### Proposed Revisions to a Standard Plans Index

Index Number: 676-010

Index Title: CABINET INSTALLATION DETAILS

Sheet 1: Changed concrete thickness in the GROUND and POLE MOUNTED CONTROLLER CABINET detail; Added Maintenance Service Slab; Updated Notes; Renumbered sheet.

9/22/2021 12:38:37 PM

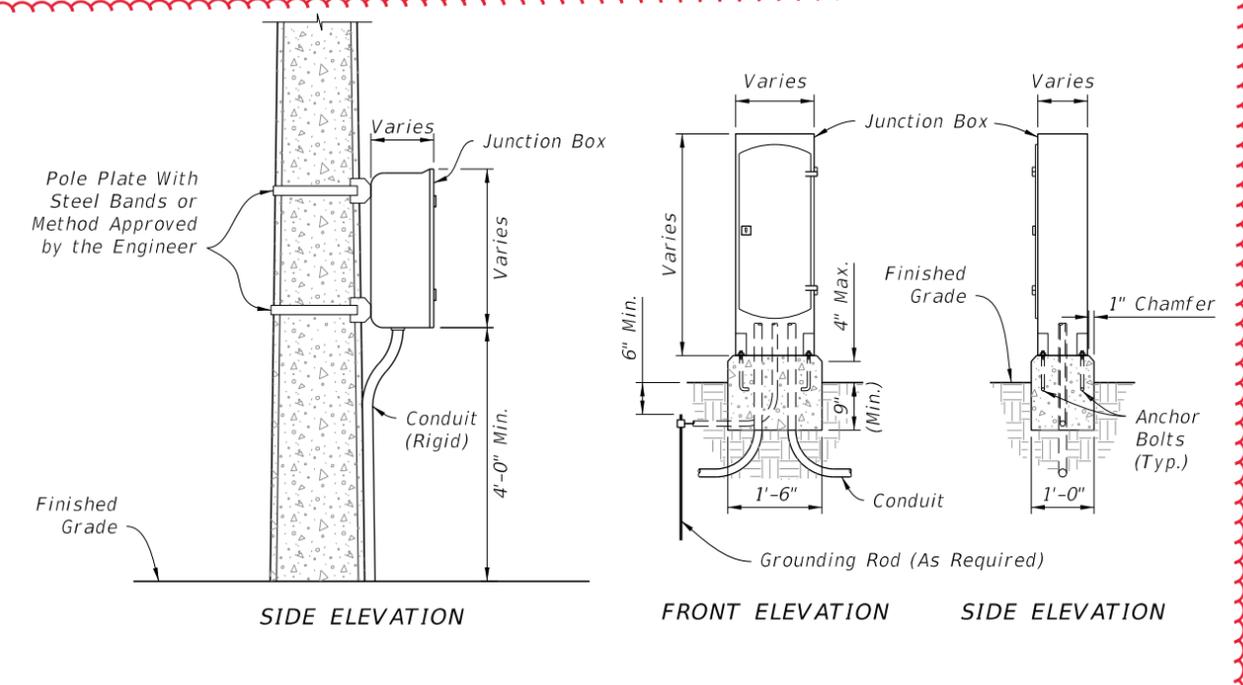
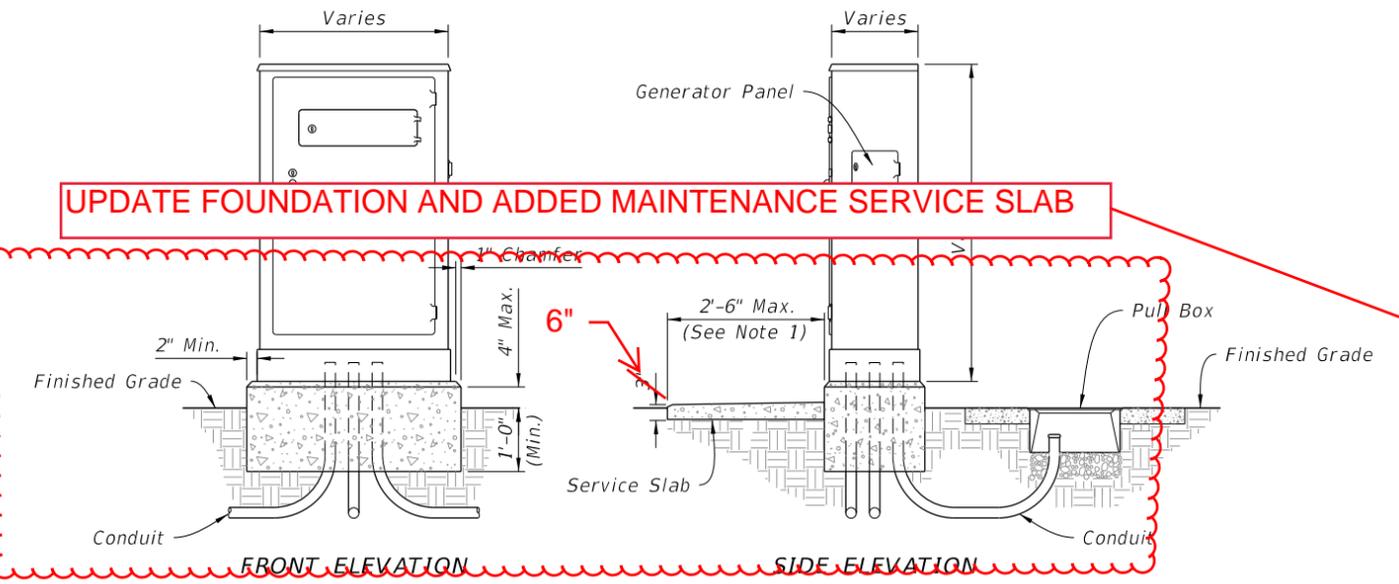
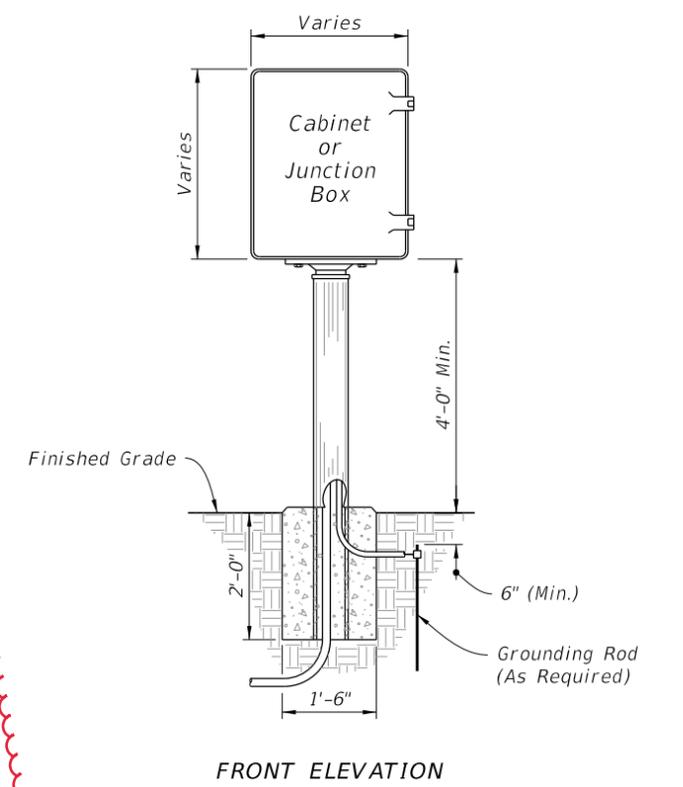
**MOVED TO SHEET 3**

**UPDATED NOTES**

**UPDATED NOTES**

**NOTES:**  
 1. Service Slab: slope 1/4" to 1" for drainage. Not required in sidewalk, pavement areas, or where R/W is restricted.  
 2. The number, size and orientation of conduit sweep will vary according to site condition or locations. Provided two spare 2" PVC conduits in all bases. Place the exits of the spare conduits in the direction of the center rear of the cabinet base and into a pullbox. If obstructions prevent the spare conduit from exiting to the rear, or the rear of the cabinet is located on the R/W line, locate as directed by the Engineer. Cap all spare conduit sweeps with a weatherproof fitting.

## NEW SHEET 2

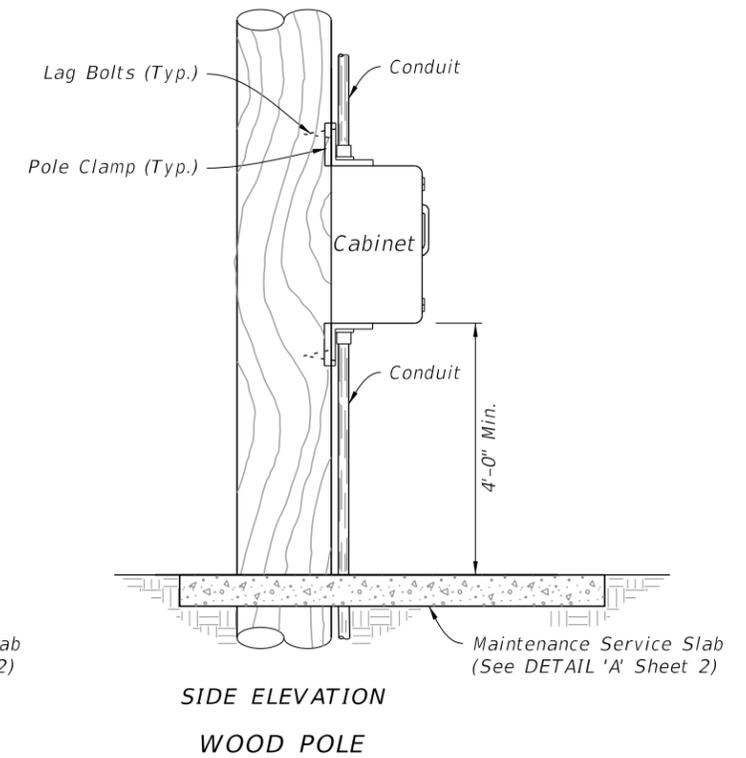
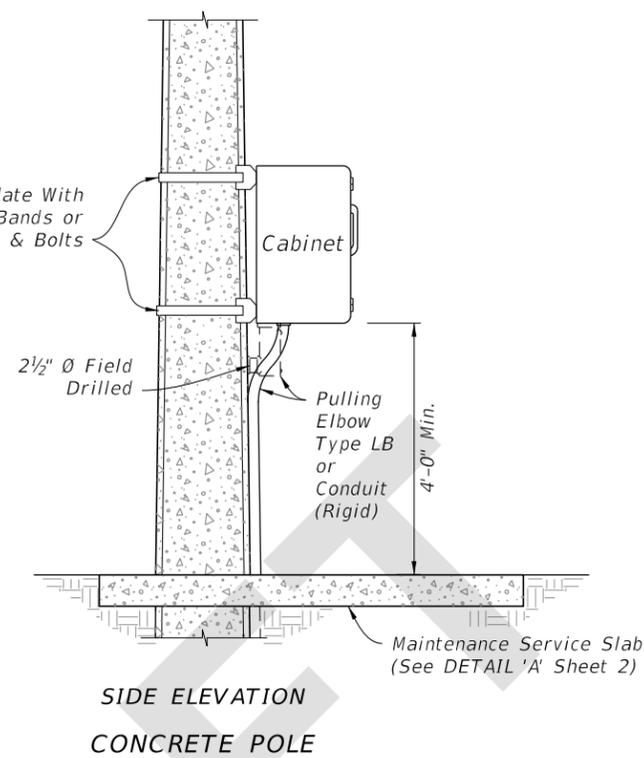
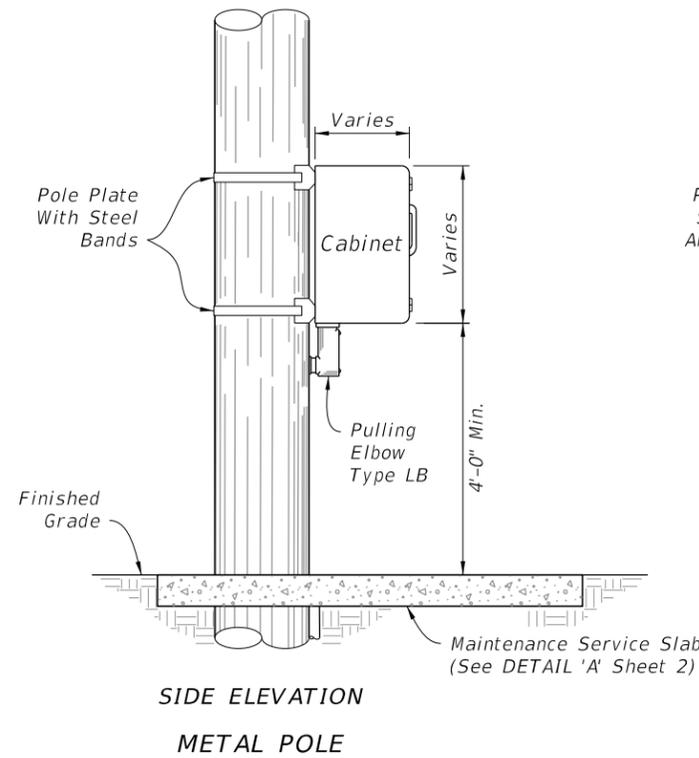
Sheet 2: New Sheet - details for Intelligent Transpiration System (ITS) cabinets and service slab requirements.

PEDESTAL MOUNTED CABINET

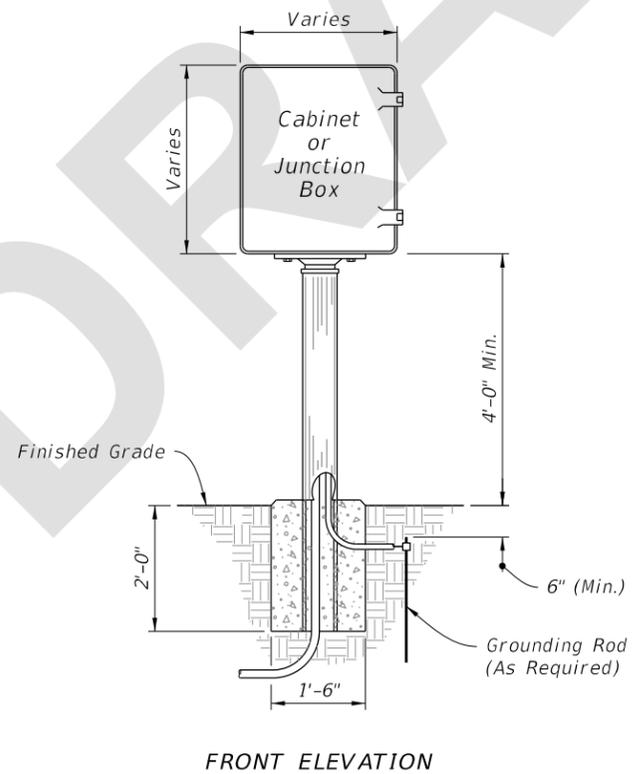
Sheet 3: New Sheet - INTERCONNECT JUNCTION BOX and PEDESTAL MOUNTED CABINET Details.
